service bulletin

No. 91. 6. 005

AIRCRAFT SAAB SAFIR 91B AND 91C, MANUFACTURING NR 91. 201-91. 320

SUBJECT: Dividing of LH and RH baffle plates in engine cooling system.

Figure 1

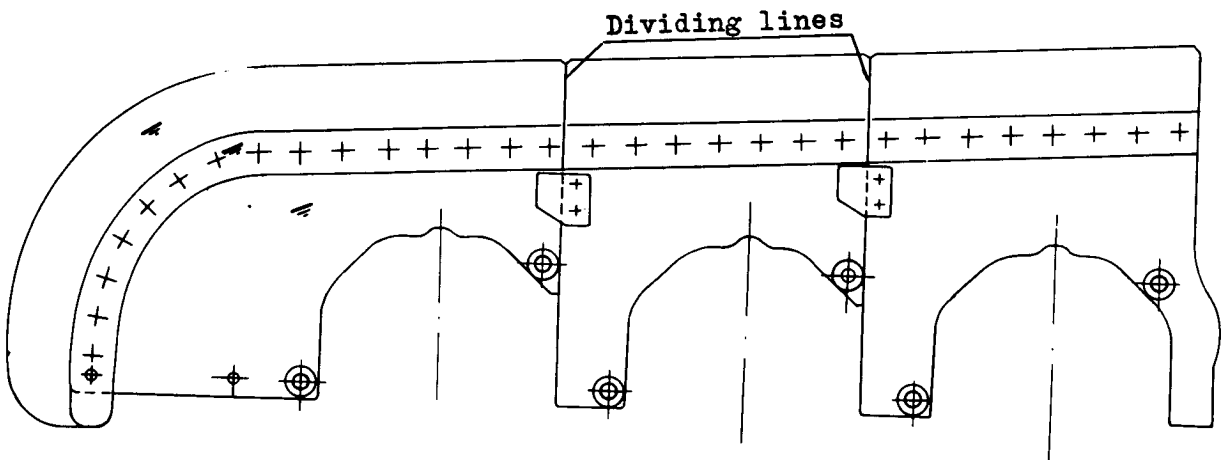
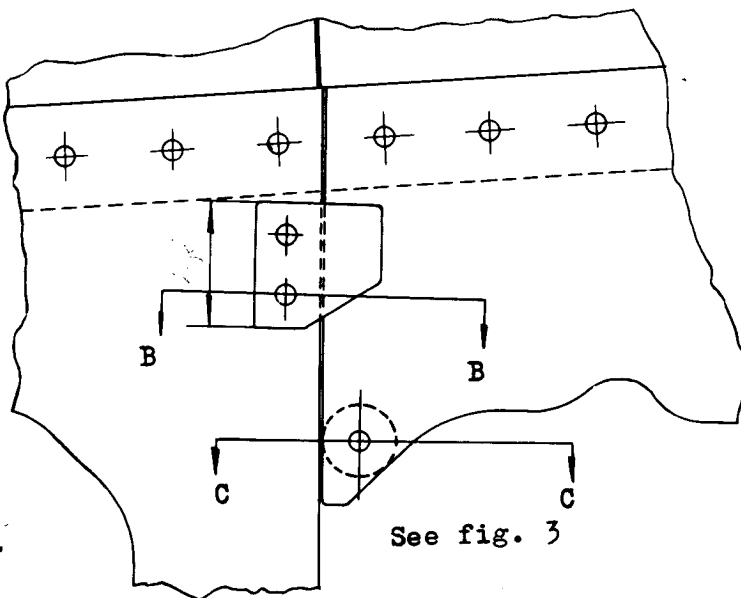
Divide the baffles and rivet supporting lugs to them according to fig. 1. The dividing lines may be slightly altered to provide sufficient edge distance at old rivets and screw holes. If the space for shim 1077856ur is insufficient, reject the shim and rework spacer 1077127 according to fig. 2.

Drill out the predrilled holes in the baffles to \varnothing 6,5 mm to fit the attaching holes on the engine. Divide the baffles and rivet supporting lugs to them according to fig. 1. The dividing lines may be slightly altered to provide sufficient edge distance at old rivets and screw holes. Spacer 1077127 and shim 1077856ur can be used, but in that case the predrilled holes shall be drilled out to \varnothing 8,5 mm.

Figure 3

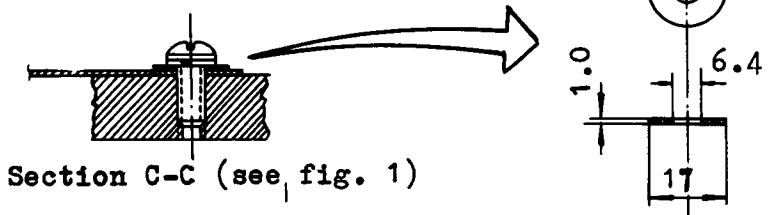
When mounting new baffles on the engine, washer 1129851 according to fig. 3 is to be preferred instead of spacer 1077127 and shim 1077856ur.
